Addendum No: 04

Project: Davis Elementary School, LUSD

Issue Date: 08/12/2026

PBK Project No: 230217 / DSA # 02-123250

C3.1

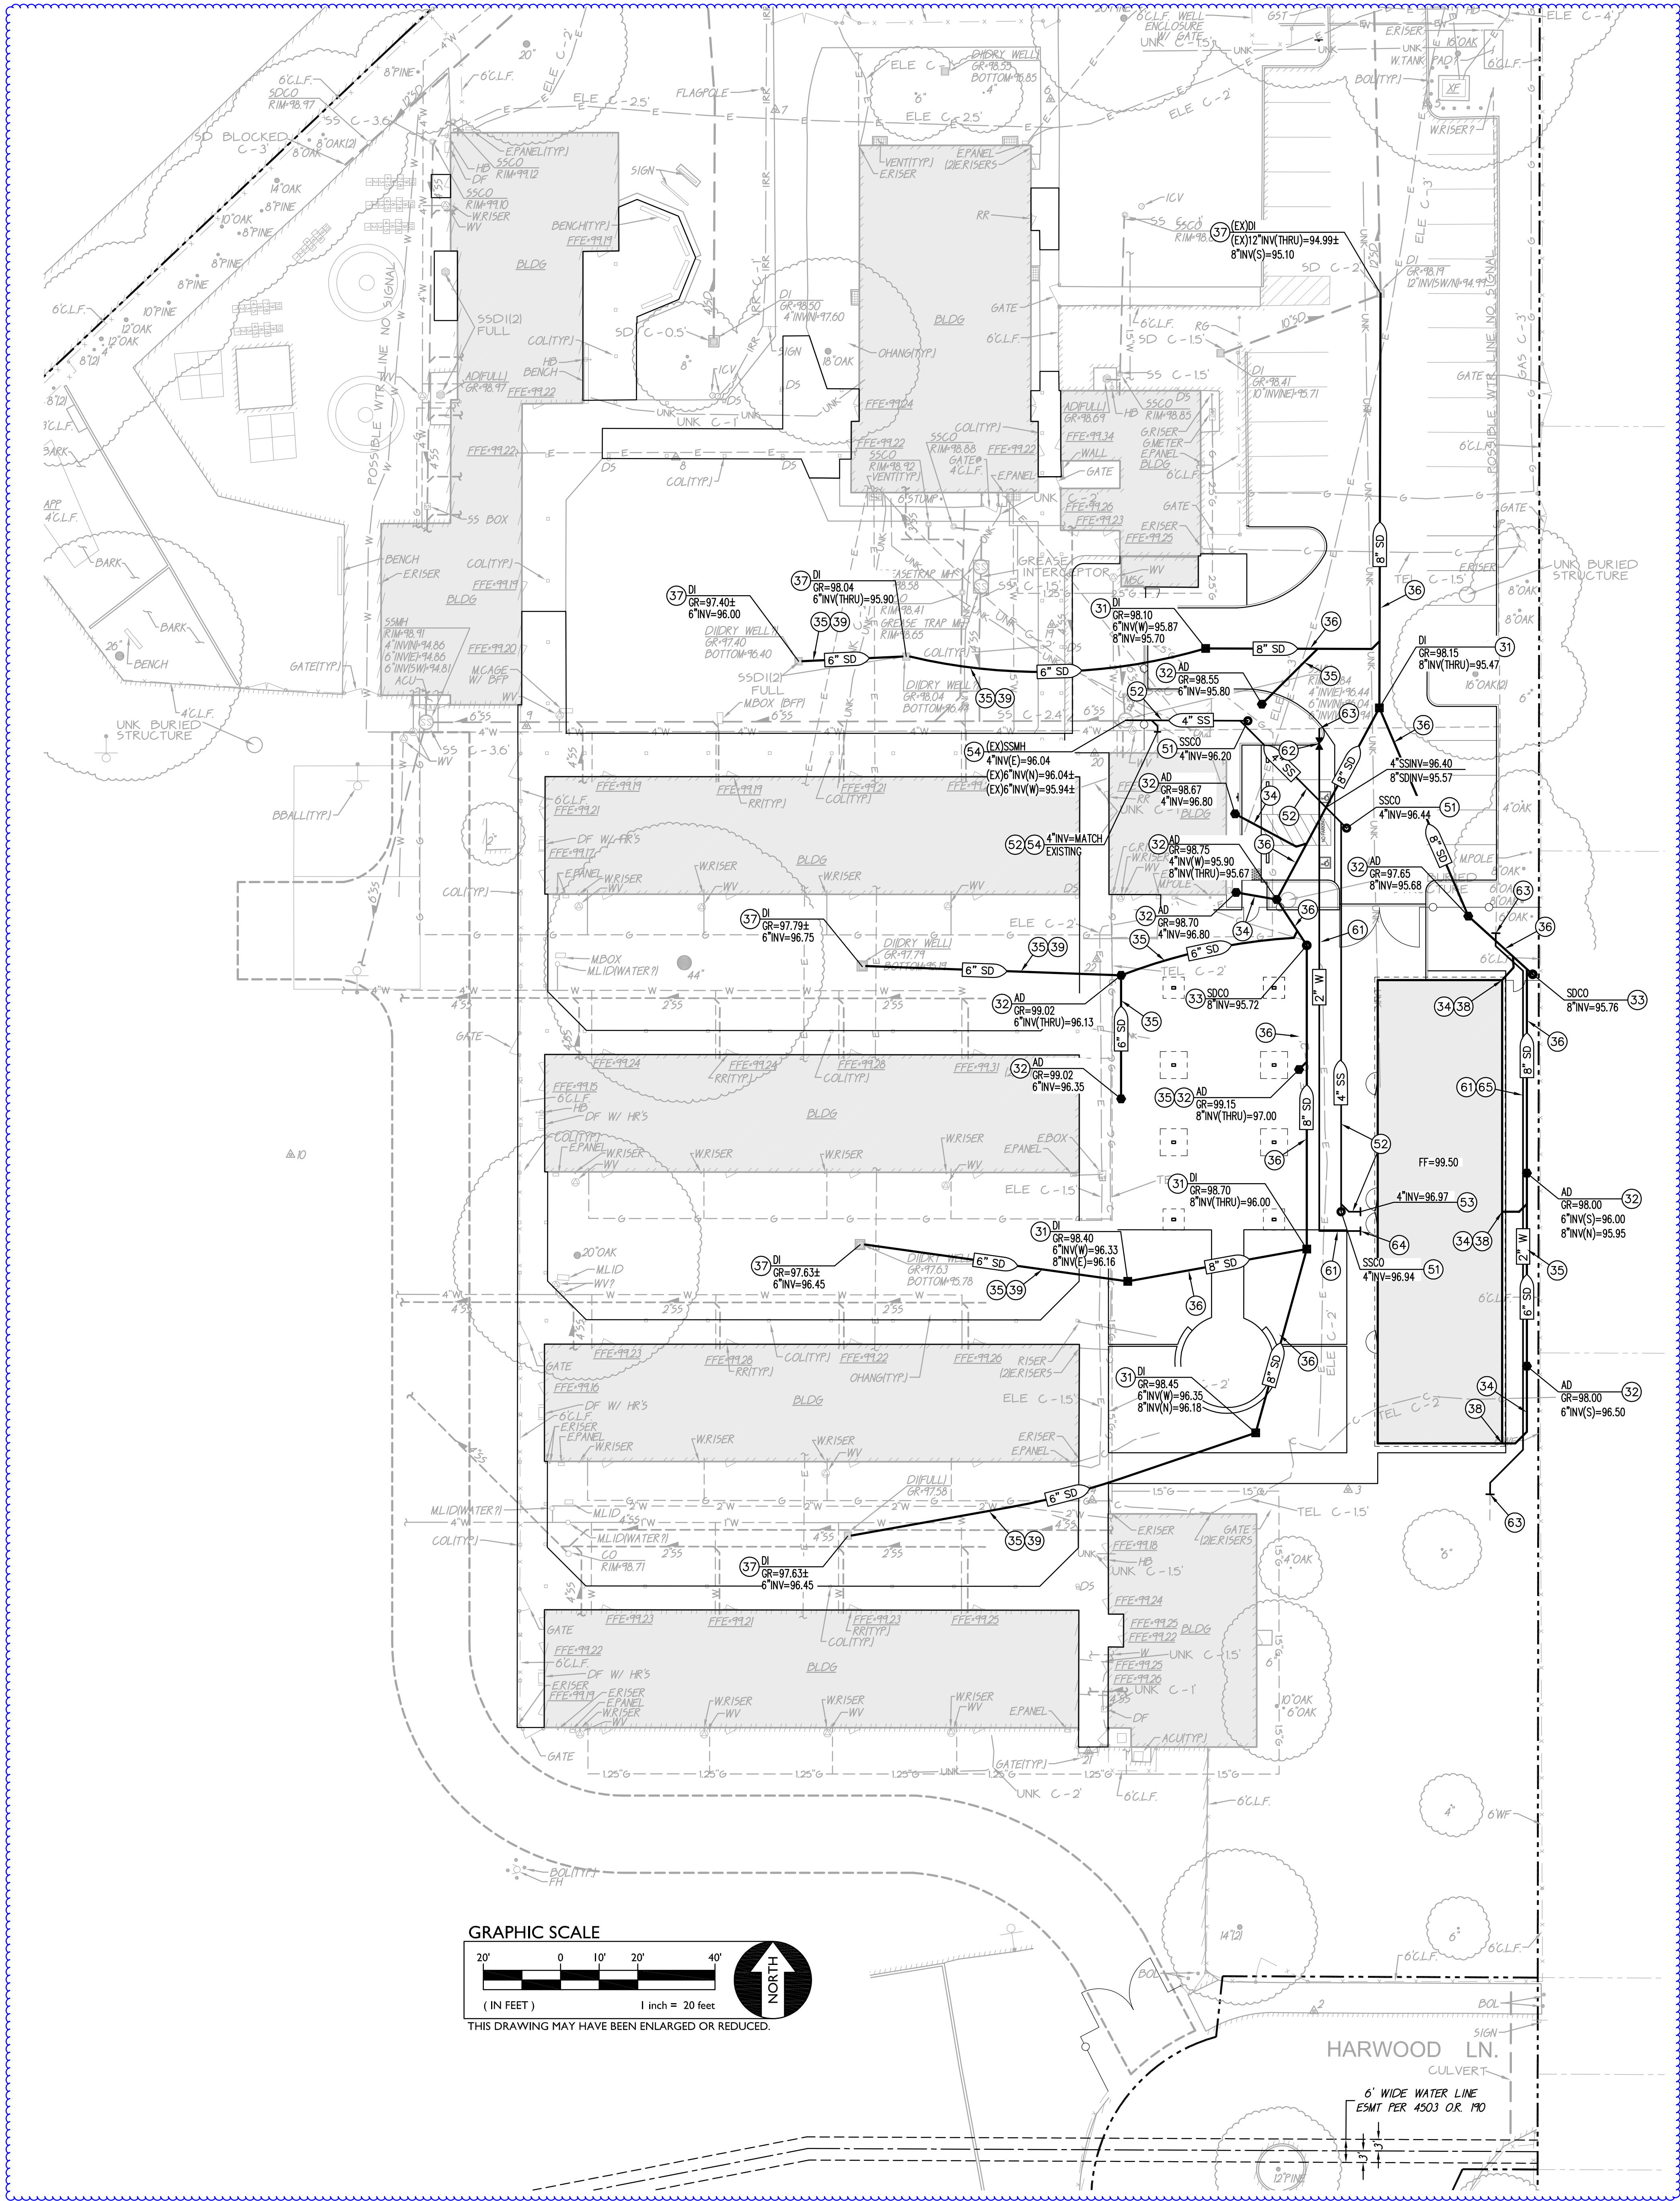
- Item 1. Replace sheet C3.1 – Utility Plan with attached sheet. Original sheet had a scaling issue, this sheet just corrects the scale on the sheet.
